# State of Utah DEPARTMENT OF NATURAL RESOURCES Division of Oil, Gas & Mining

# Inspection Report Minerals Regulatory Program

TAILUE MAINE. INNIN COMMINOUS	N	<b>Aine</b>	Name:	Rim/Columbus
-------------------------------	---	-------------	-------	--------------

Permit number: M0370006 Inspection Date: July 30, 2008 Time: 10:15 AM – 12:15 PM

Photo 4. This pond is below the waste rock pile at the Rim mine and looks like a sediment pond. There appears to be a natural seep at the pond.

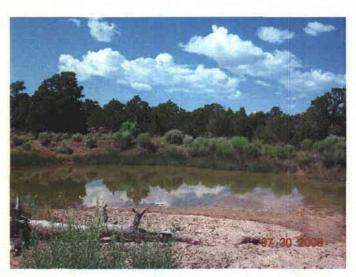
The drainage system at the Rim mine is such that most of the water is routed away from the pond below the waste rock pile (see Photos 4 and 6). The pond appears to be in an area with a natural seep, and I am not sure whether it is considered a sediment pond, a stock watering pond, or something else. Maps in the Division's file show it within the disturbed area.

I recommend that ditches at the shaft be modified so runoff would flow into the pond below the waste rock pile.
